CITY PROJECT # 07-24

PALM SPRINGS ANIMAL CARE FACILITY

ADDENDUM NO. 1

PLANTER #1 PARTIAL FOUND. PLAN AT EXIST. 18" STORM DRAIN PIPE

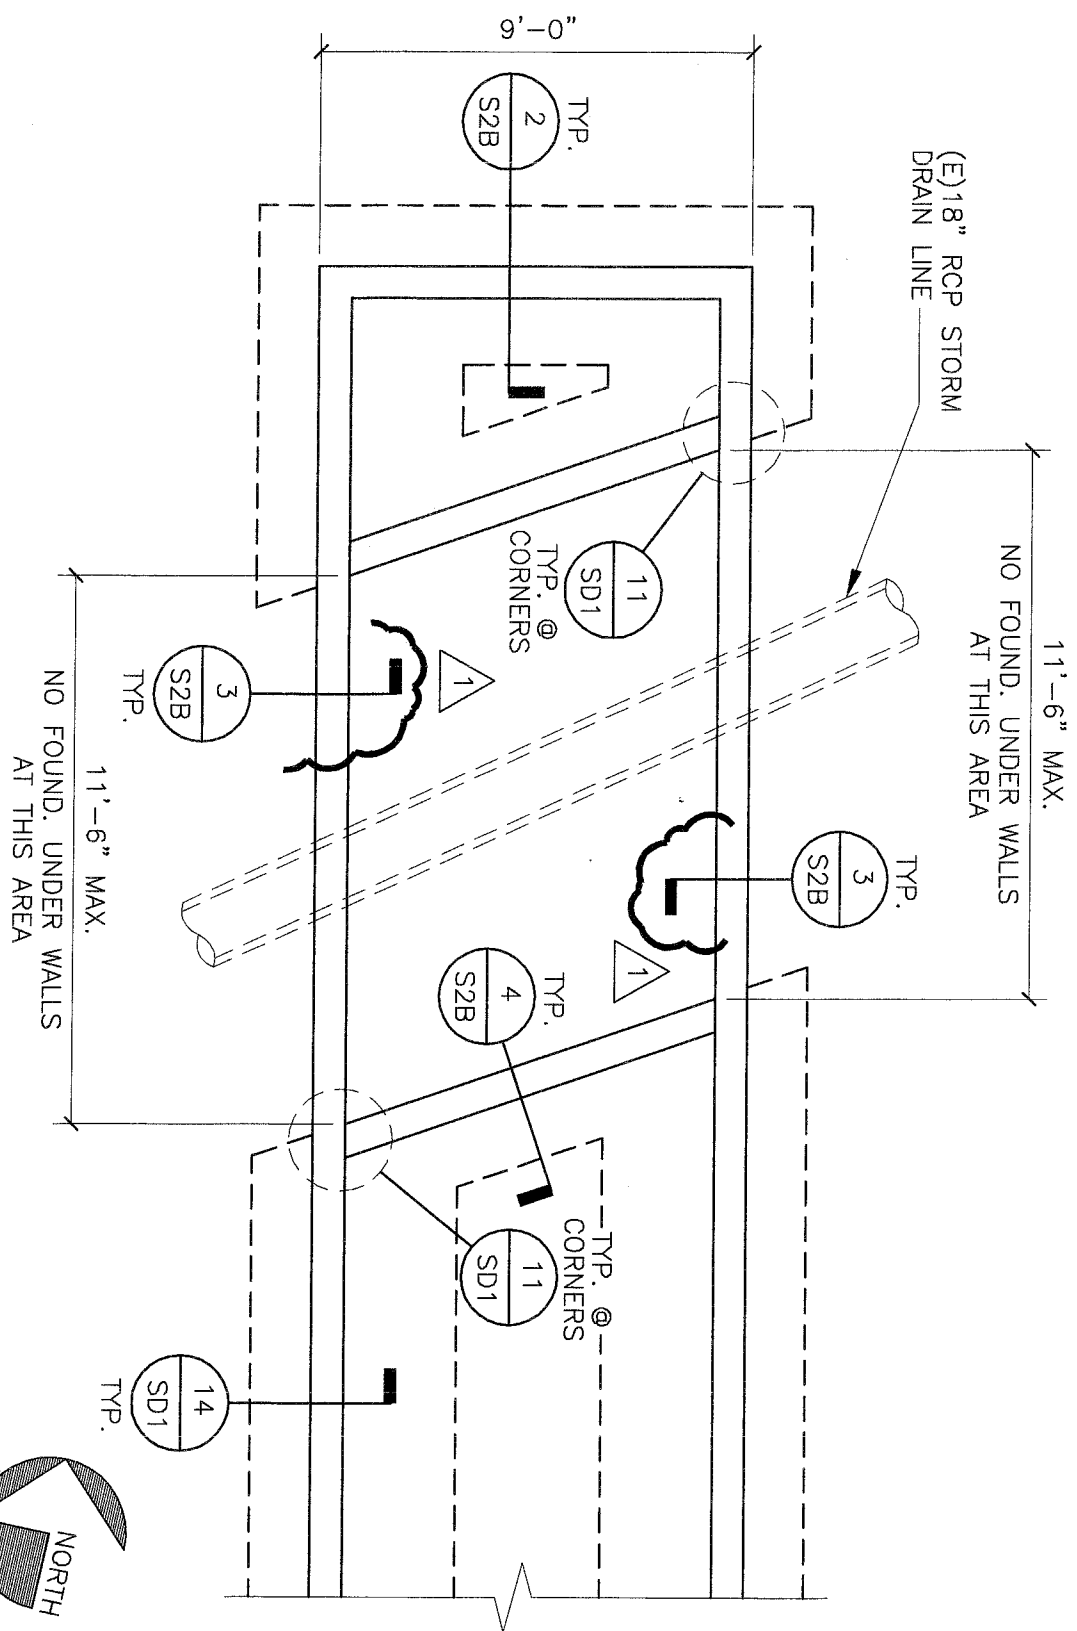
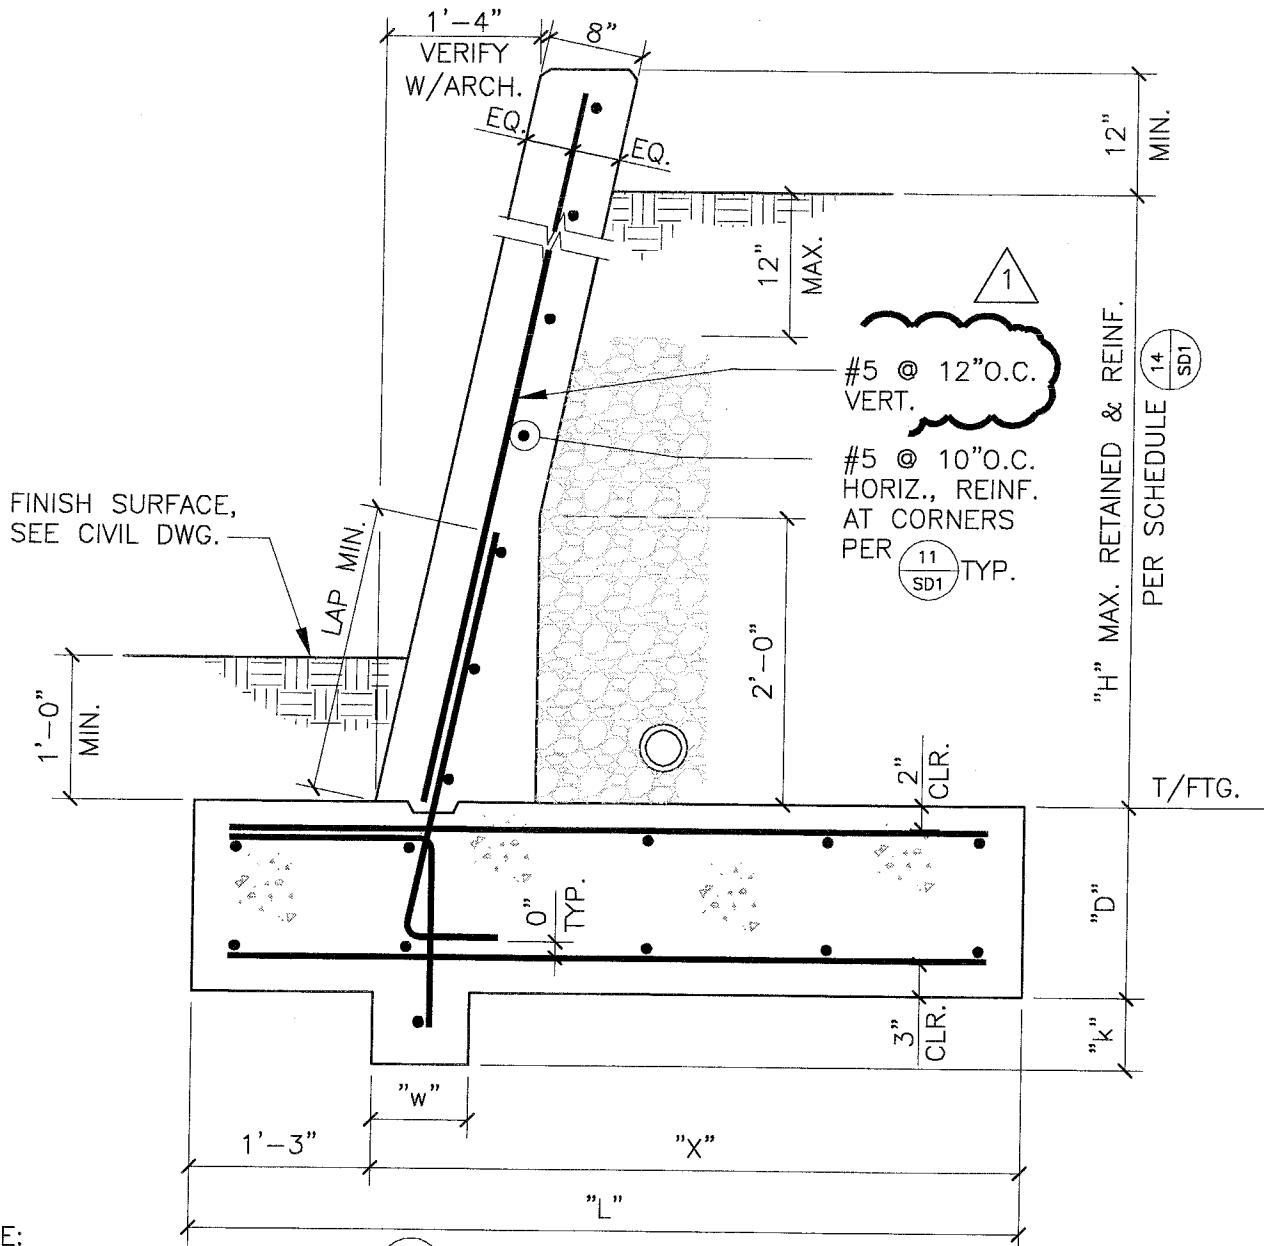
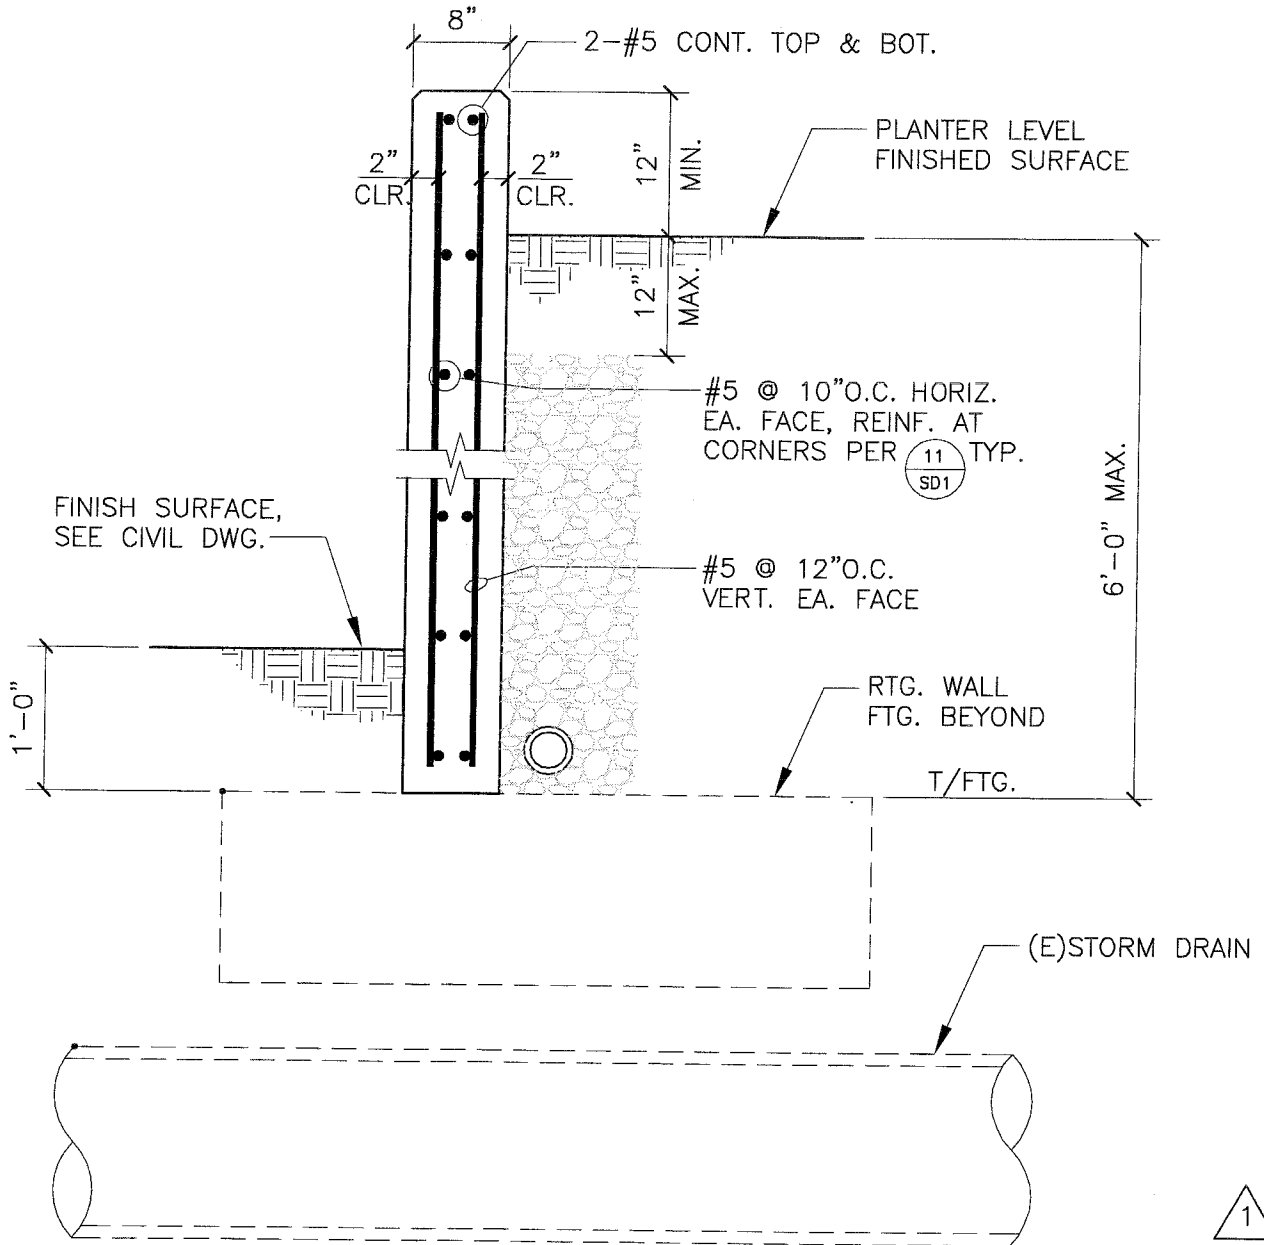
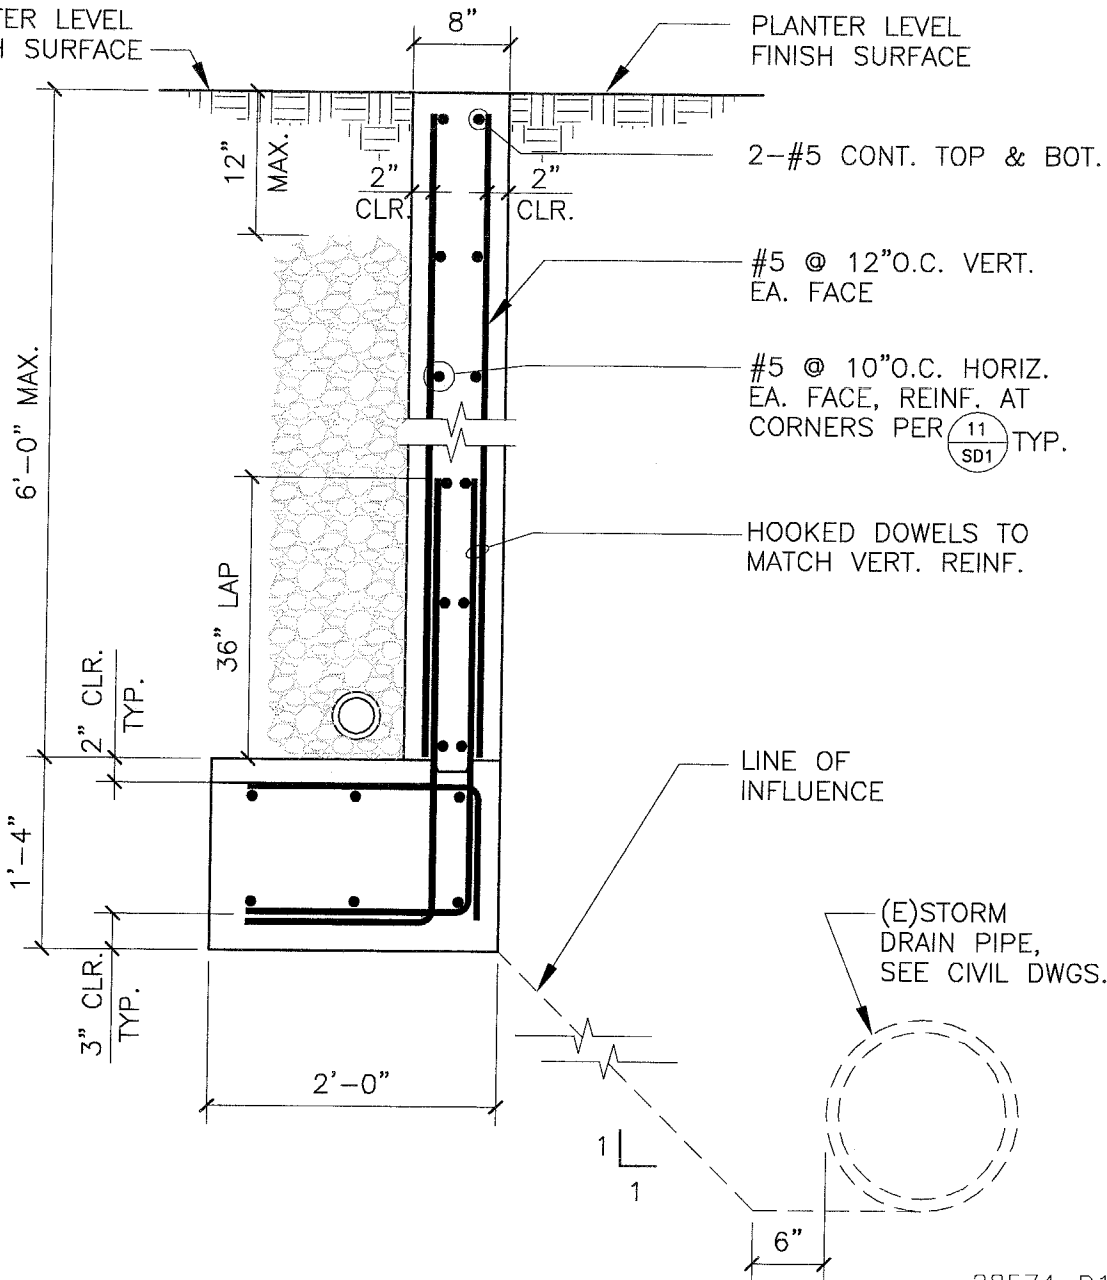
9. **A1-E11:** Revision to Drawing Sheet E5.2 adding note for bonding jumper to structural steel adjacent to Vella Rd.
10. **A1-S1 to A1-S4:** Revision to Drawing Sheet S2B concerning foundations for Planter #1.

2 LOWER ROOF PLAN
S4A SCALE: 1/8"=1'-0"

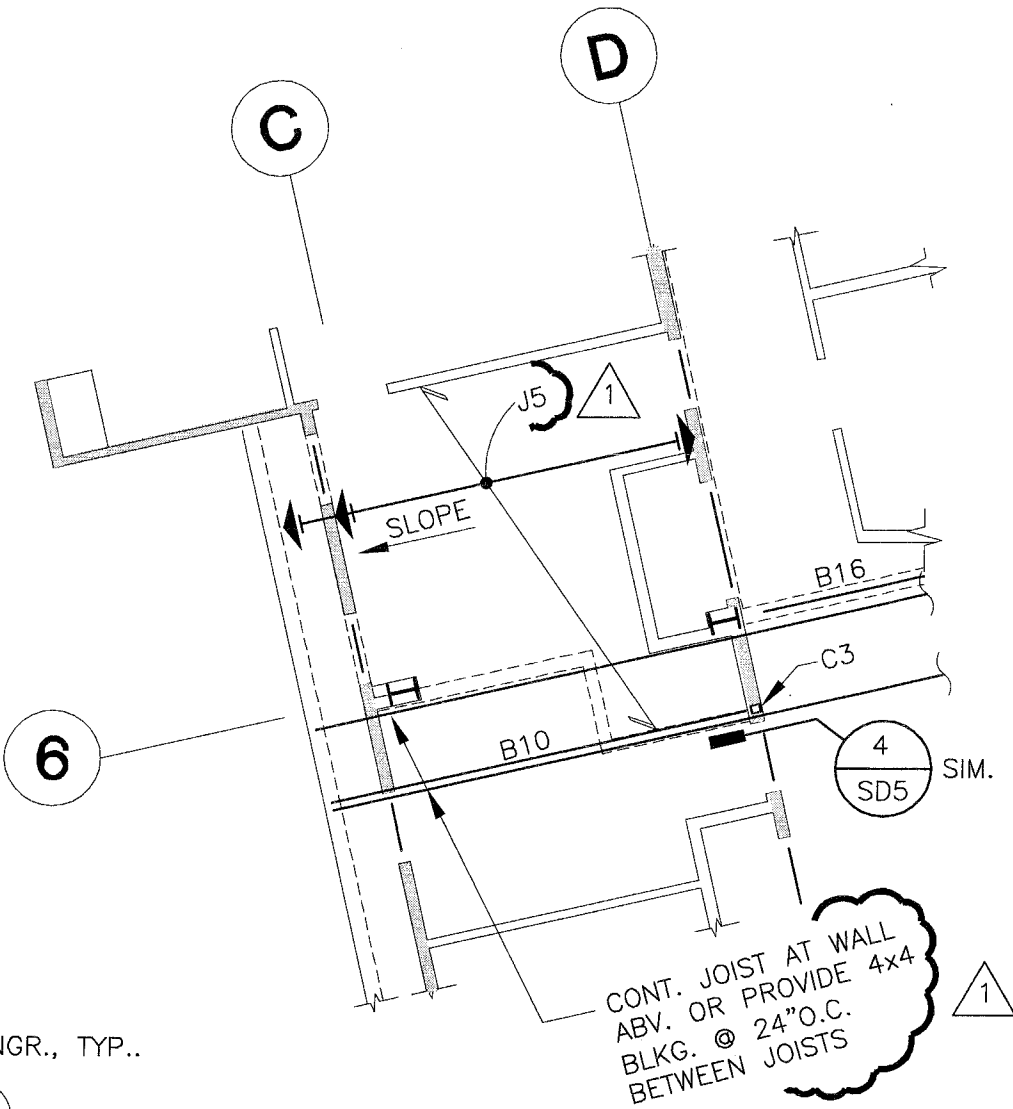
11. **A1-S5:** Revision to Drawing Sheet S2A – 2 pad ftgs at steel columns at C and B.2 added.
12. **A1-S6:** Revision to Drawing Sheet S4A – Framing specified at lower roof.

01/27/10	ADDENDUM - NO. 1		Sketch Number A1-S7
Scale N.T.S.	Project Name and Number PALM SPRINGS ANIMAL CARE FACILITY		
By JH/EA	Drawing Reference S4A	File Name

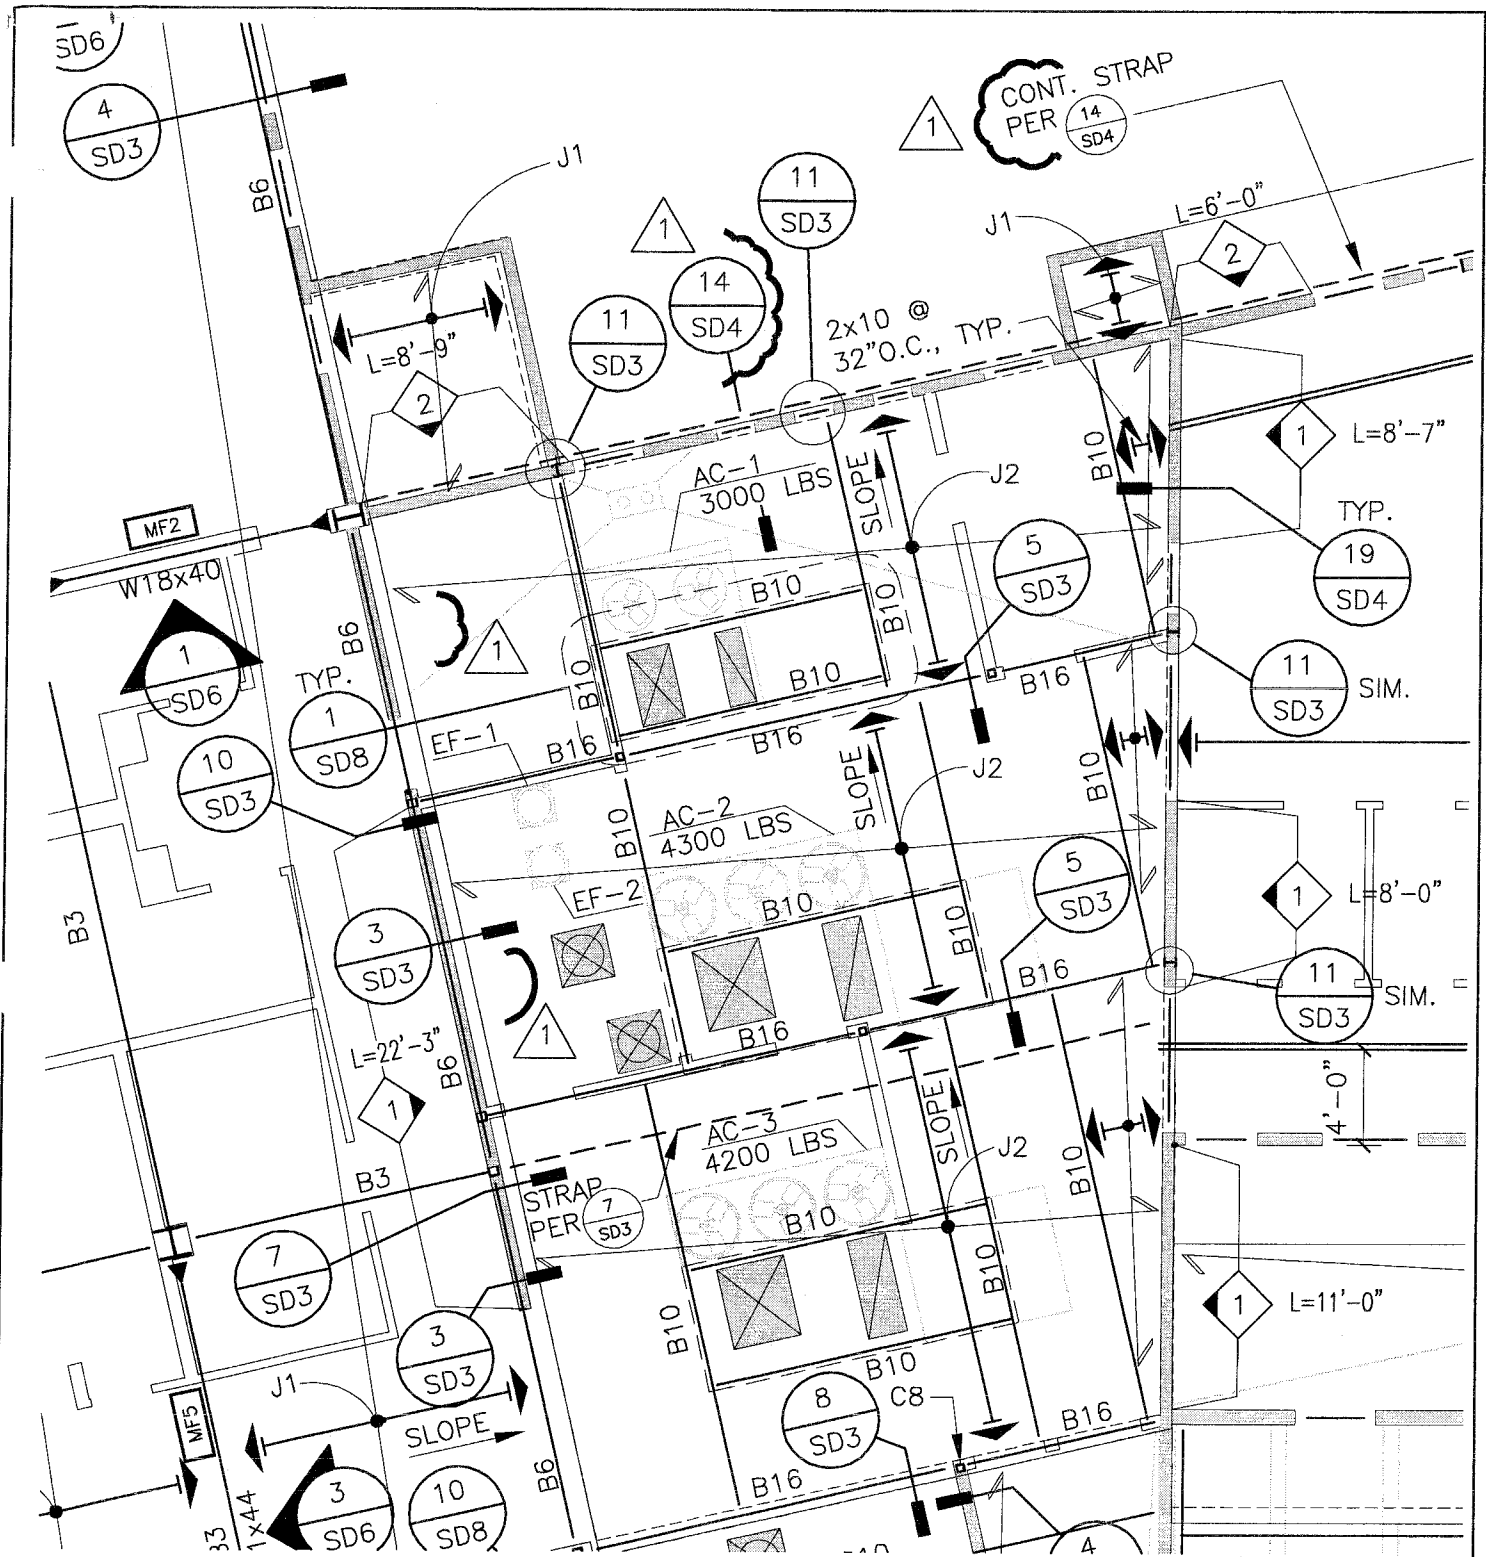
13. **A1-S7:** Revision to Drawing Sheet S4A – Steel beam 6" (at lower roof) at D between 2 and 3.8 has been eliminated. Detail 14SD4 has been called out at grid 2. Strap along gridline 2 added.

Sketch Number
A1-S8

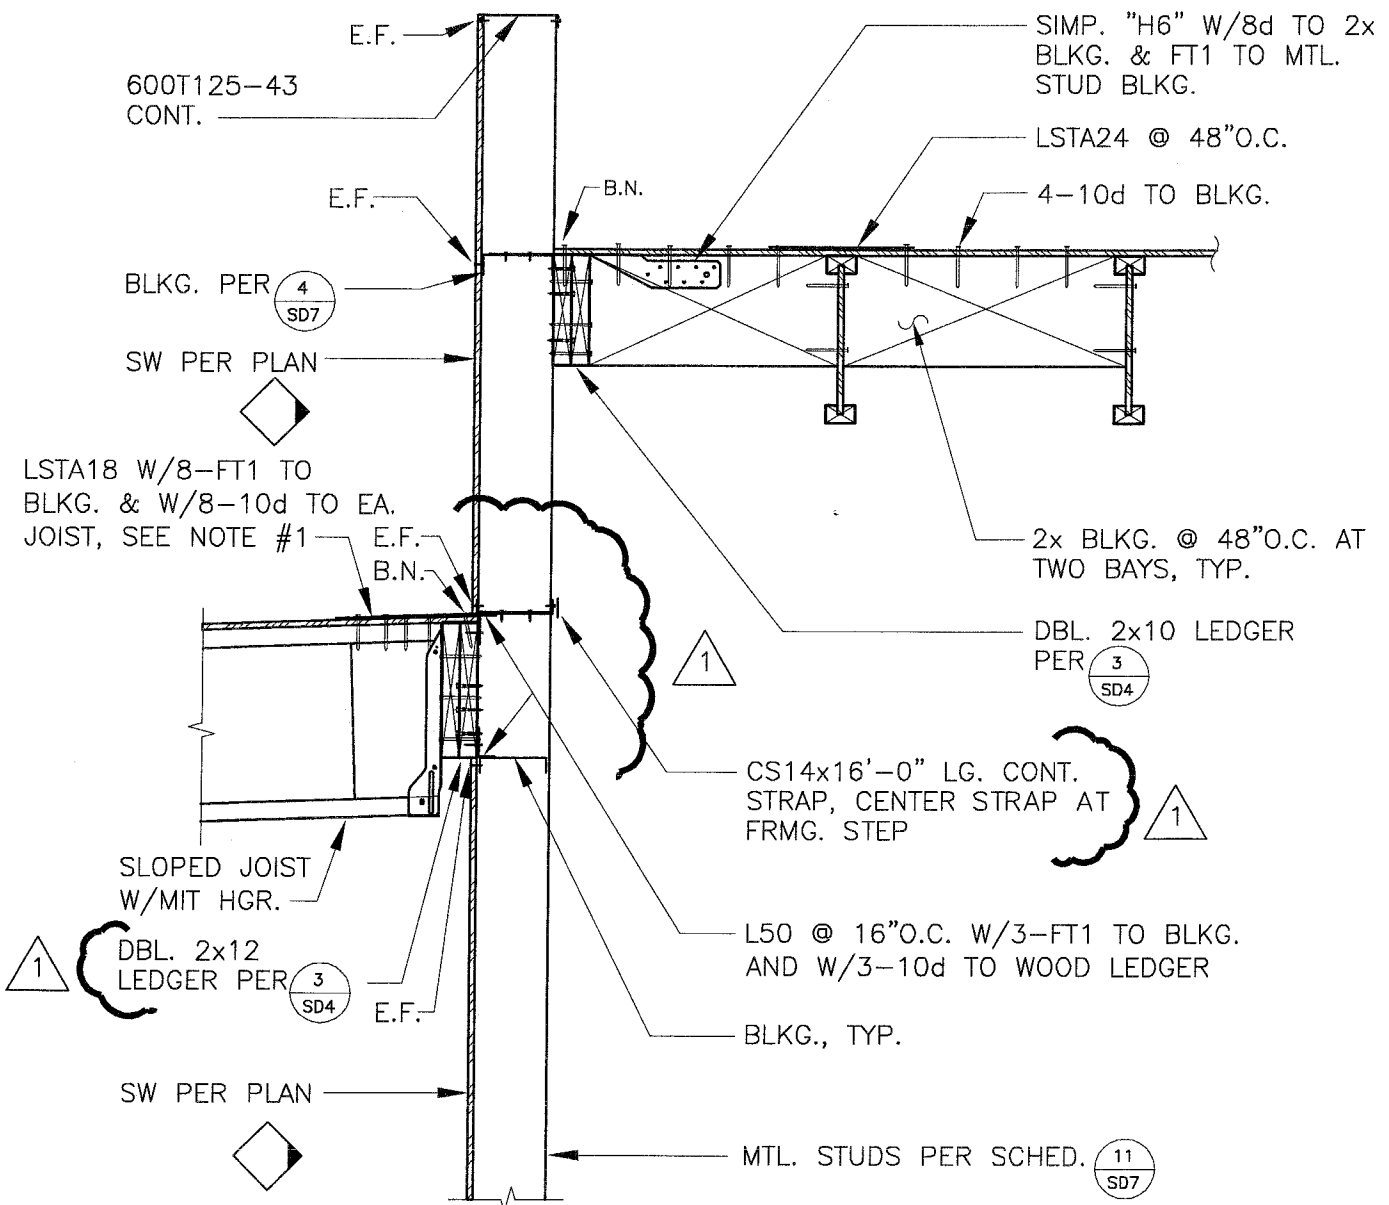
14. **A1-S8:** Revision to Drawing Sheet SD4 – Bearing at lower roof joist revised.
15. **A1-S9:** Revision to Drawing Sheet SD5 – Steel plate between columns removed.

NOTE:
 1. USE SIMP. "H6" BTWN. STUDS WHERE JOIST ALIGN WITH STUDS, TYP.
